Addendum Number 3, September 13, 2023

RE: Mobile Civic Center Parking Facility
Mobile, Alabama
C-085-22

FROM: Evan Terry Associates, LLC
One Perimeter Park South, Suite 200S
Birmingham, Alabama 35243

2 DETAIL OF FIRE PROTECTION DRY PIPE SYSTEM
NOT TO SCALE

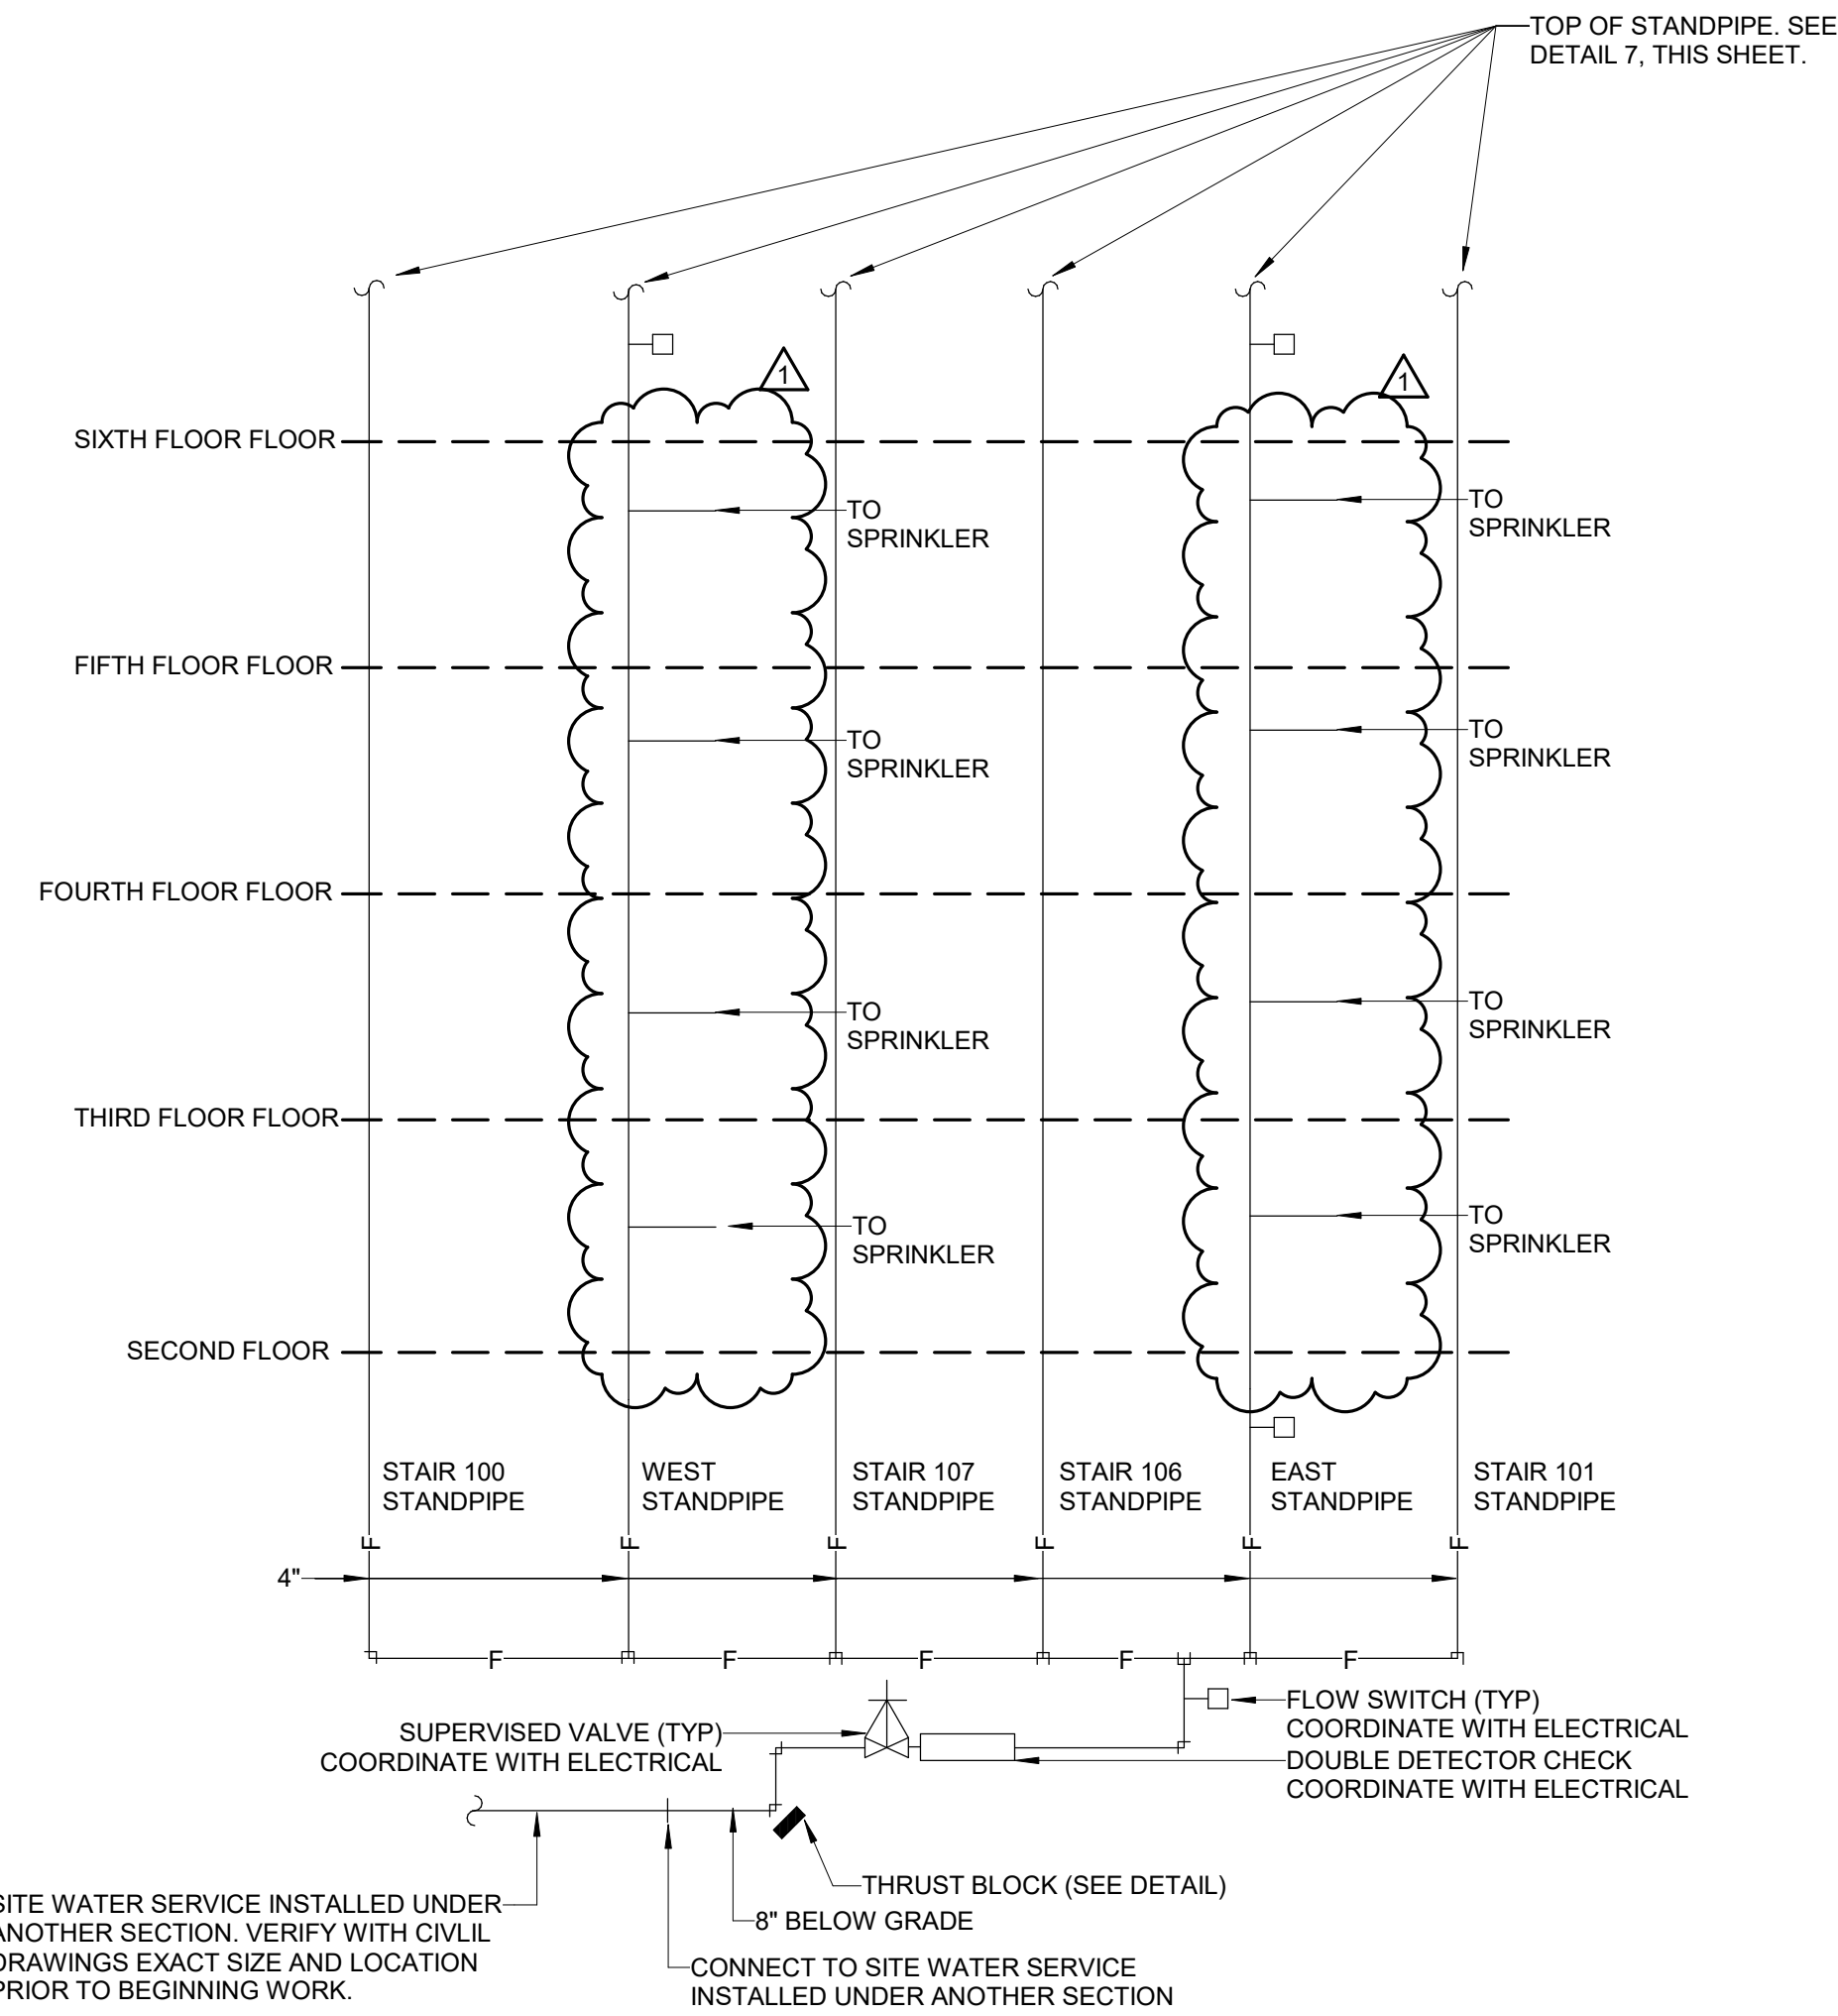
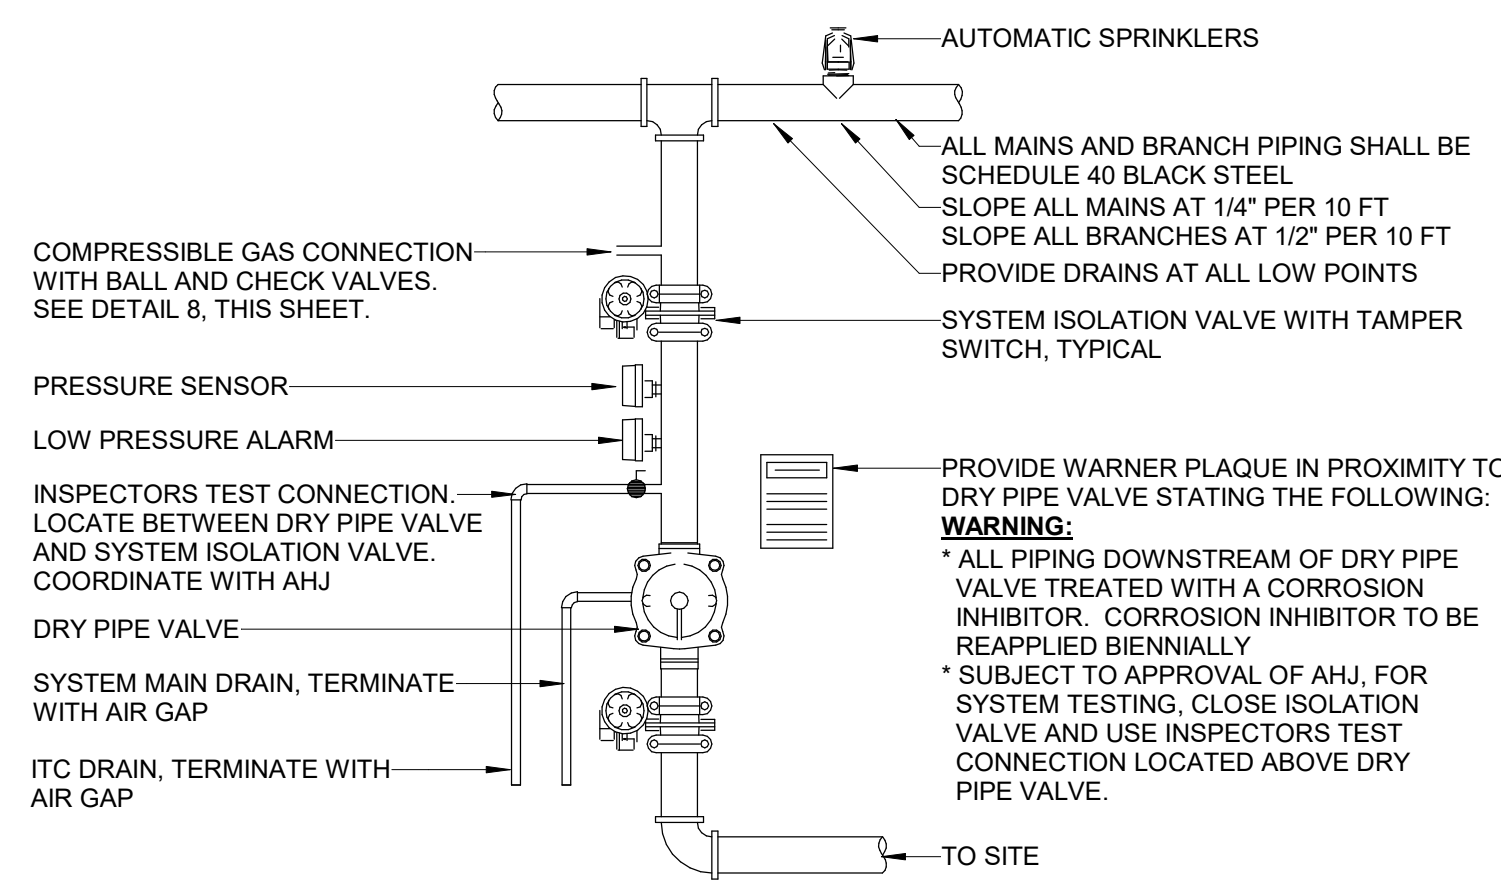
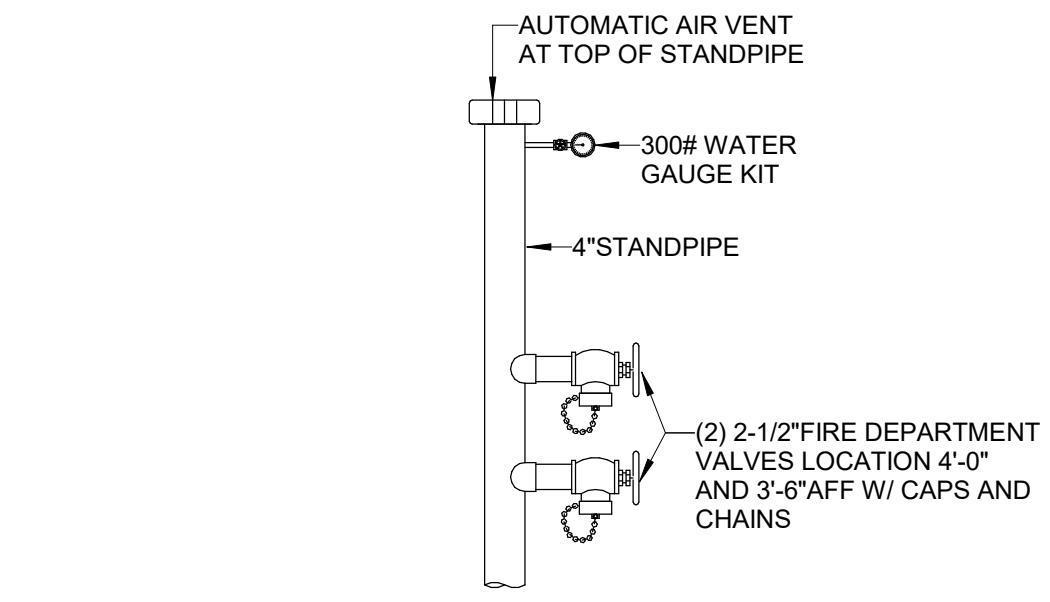
Item 33 F0.01, Sprinkler Notes #2 says 1-1/2” and smaller is to be schedule 40 and Sprinkler Notes #3 states 2” and larger to be schedule 10. F2.01 says all mains and branch pipe to be schedule 40 per detail 2 notes. The Division 21 specifications do not have restrictions on schedule 10 piping being installed. Which is correct?

RESPONSE The notes on sheet F0.01 have been edited to reflect the notes from Detail 2 on sheet F2.01. This project should include only schedule 40 piping for the dry system.

MOCKUP PANEL - PRECAST

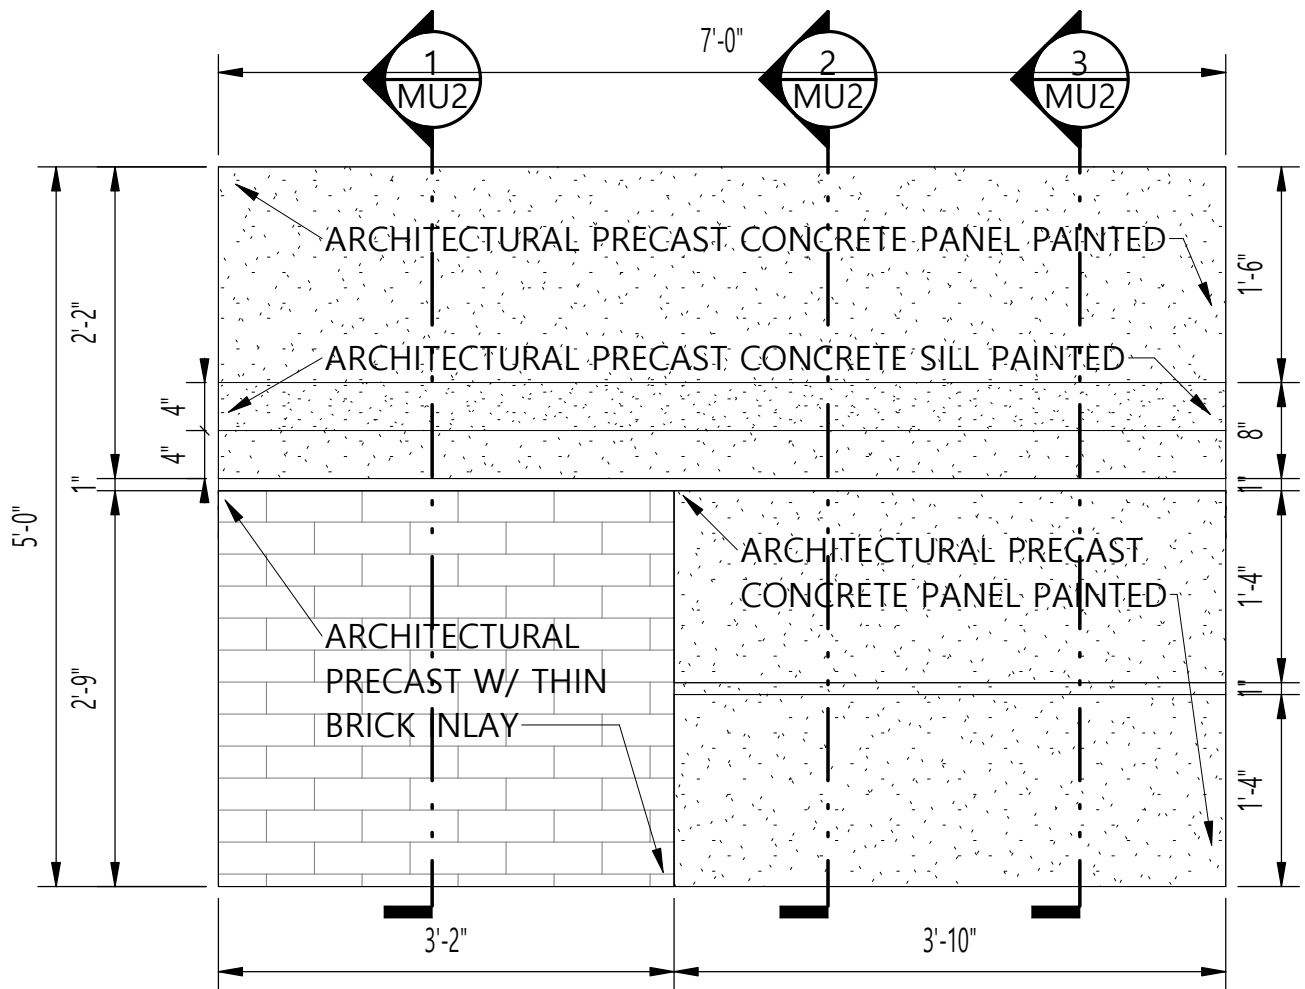
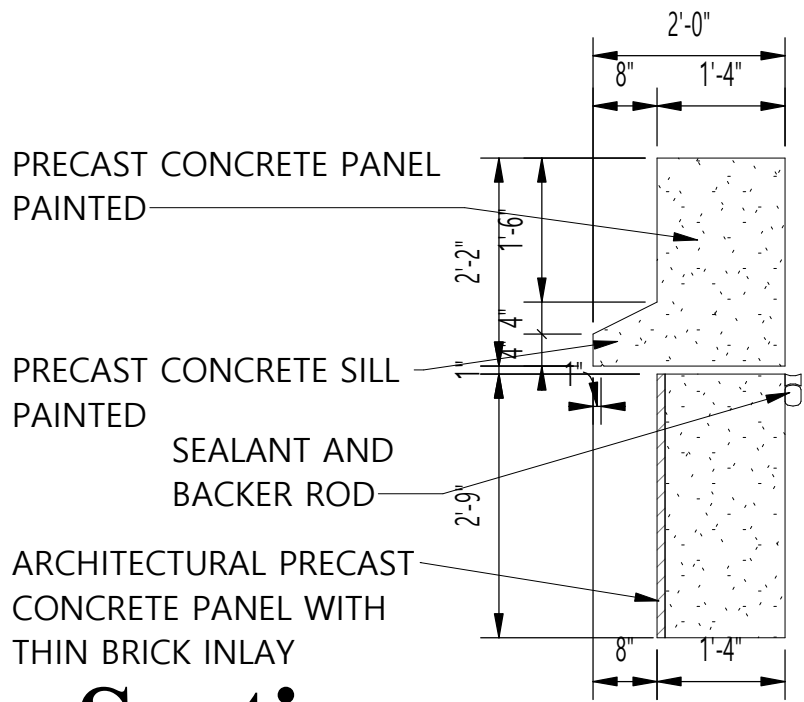
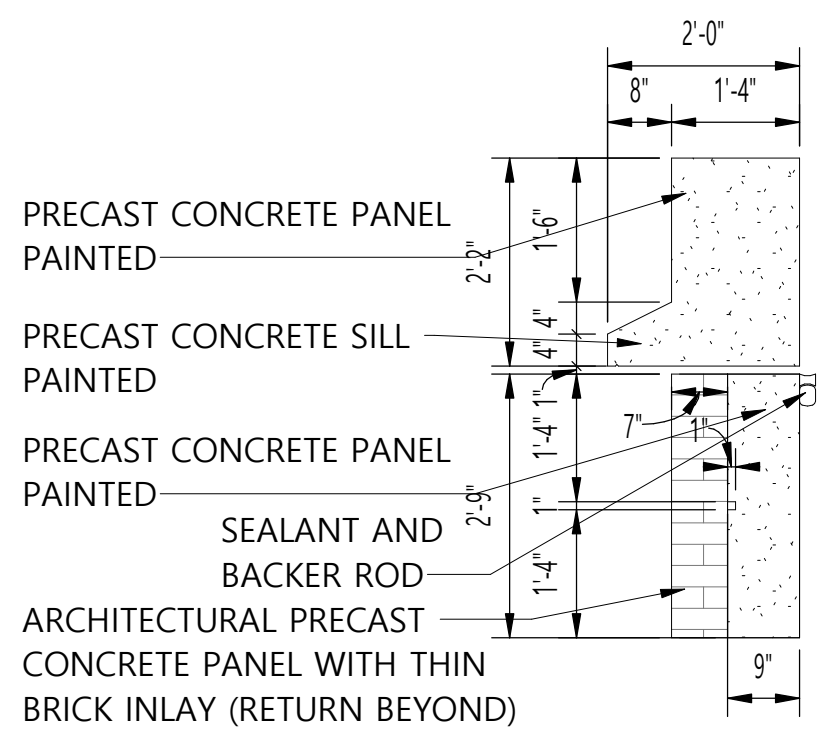
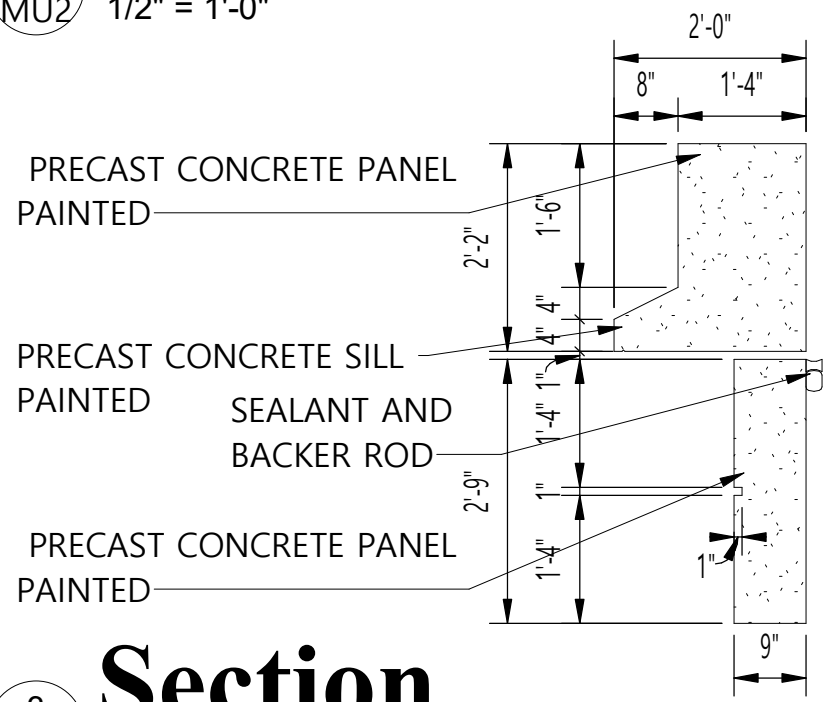
- RESPONSE Precast to be form finish.**
- ITEM 46 Precast is gray to be painted, so is the mortar joint between the brick gray?
- RESPONSE Gray**
- Item 47 Mock up is called for 6'x8' panel in the specifications, does this include brick and sill?

- RESPONSE Refer to the precast mockup drawings, copy which is attached hereto.**
- ITEM 48 What is the color and manufacturer of the brick?
- RESPONSE Refer to the specification section 01 12 00 Allowances for thin brick allowance.**
